STAFF REPORT: SEPTEMBER 11, 2024 MEETING

APPLICATION NUMBER: HDC2024-00495

ADDRESS: 3747 TYLER

SCOPE: INSTALL WOOD WINDOWS, DOORS AND ERECT REAR PORCH

Front Wall - Proposal

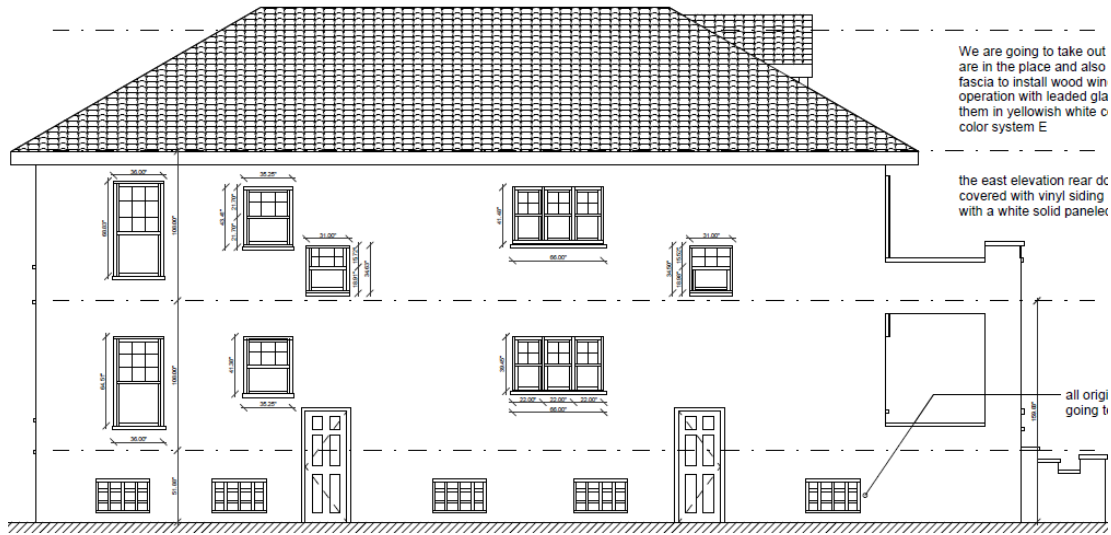
- The leaded glass windows were removed without HDC approval, therefore, the only replacement windows that would meet the requirements of the historic ordinance (Section 21-2-59(e)), are new leaded glass windows, with an identical pattern, within every window opening.

- If the Commission considers not requiring leaded glass windows to be fabricated for the front elevation openings, it is staff's opinion that the window operations must be matched to retain the verticality and rhythm of the original window arrangement. It is also staff's opinion that a muntin pattern should not be specified for these windows. The muntins/grilles would be substantially thicker (in width and depth) than the lead caming and would only be available in a horizontal/vertical pattern as shown on the elevation. This would establish new geometric patterns for the windows and significantly reduce the glass area; all of which, in staff's opinion, would conflict with, and detract from, the highly ornamented wall surfaces and window hoods.

Recommendation One – Denial – Replacement of leaded glass windows and wood doors with leaded glass panels at façade

The wood windows proposed for the façade and replacement door at the upper porch do not meet the Secretary of the Interior’s Standards for Rehabilitation for the following reasons:

- The historic windows and upper porch door were distinctive, character-defining features of the house, and their removal substantially altered the appearance of the building. The only replacement windows that will meet the Standards are new leaded glass windows, with an identical pattern, within every opening, as well as glass door panel.
- The proposal to install a solid panel door and wood windows that have a traditional muntin pattern rather than the leaded glass pattern will not restore nor improve the historic and architectural design of this property.
- The uniformity and relationship between the window openings on each floor and each elevation is an important architectural component of the dwelling. The casement units on the front elevation offered a verticality to each window opening that will not be duplicated by the installation of double-hung windows at the second floor.

Left- East Side Wall

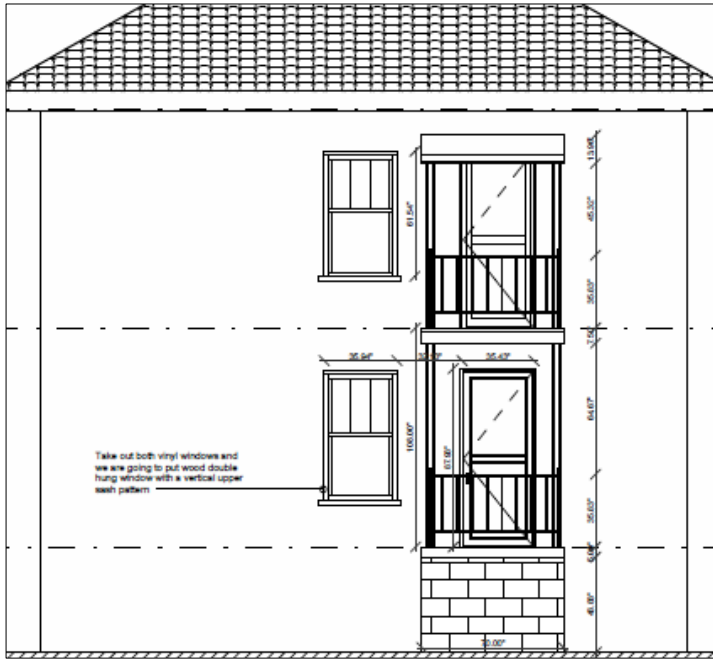
- The current application reverts to matching the historic window operation of each opening on this wall. However, the historic muntin pattern was a linear 3-over-1, not 4, 6 and 9-over 1.
- This dwelling is a two-family flat, and the application includes the installation of a new doors within each existing door opening. The six-panel offers a minimal design with vertical proportion, and it is staff's opinion they are compatible for this property, however the selected color of white is not compatible with the architectural design of the dwelling.

- For the replacement windows at the side and rear walls, solid wood or aluminum-clad wood windows will be selected. Cut sheets confirming the manufacturer, product line, material, operation, color, and simulated divided light dimension and profile will be submitted for staff review. All double-hung windows will have a 3-over-1 pattern, and the small square windows will not have any glass pattern. A window schedule that confirms the details for each window will be submitted for staff review.

- The six-panel doors proposed for the side and rear elevations will be dark brown. A cut sheet confirming the design, color and material will be submitted for staff review.

Rear Wall

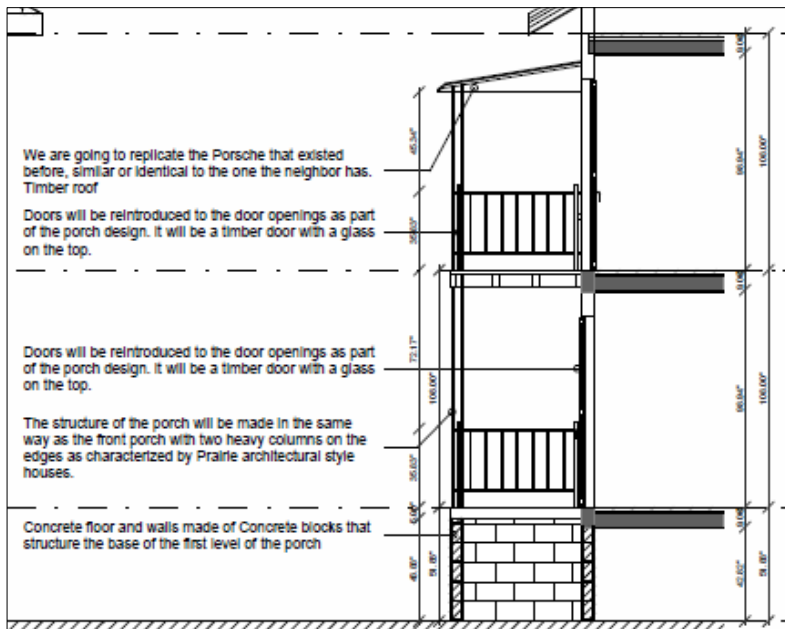
- The application proposes to remove the vinyl windows and install wood windows with a 3-over-1 pattern to match the documented historic condition. A two-story porch is proposed in a dimension and design that is similar to the ghost images shown in the 2018 photo that documents the placement of the former porch.

Applicant drawings

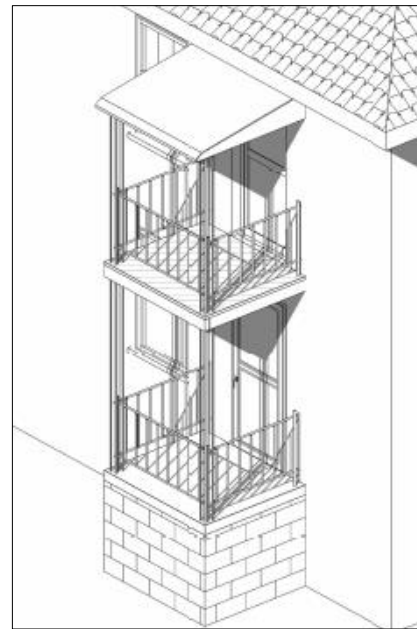
- It is staff's opinion that the historic porch was likely wood construction (based on the width of the railing profiles) and that wood construction for the new posts, railings and landings (no concrete block or iron railings/posts) would be compatible at this rear, secondary location. An awning for the upper porch, as drawn, is also a compatible design option at this location.

- The aluminum coil stock that was installed to cover the window opening's wood brickmould will be removed.
- The two-story rear porch will specify wood components for the posts, railings and decking. The perimeter railings will have a top and bottom rail and vertical spindles and will be tied into the porch's supporting posts; a freestanding, independent railing system as currently proposed will not be selected. The entire porch system will be painted three – six months after installation; paint color will be submitted to staff for review. If an awning is selected to cover the upper porch, a catalog cut of the product that includes the dimensions, method of installation, materials, fabric color and pattern will be submitted to staff for review. A revised dimensioned elevation drawing of the two-story porch that calls out materials and finishes will be submitted to staff for review.
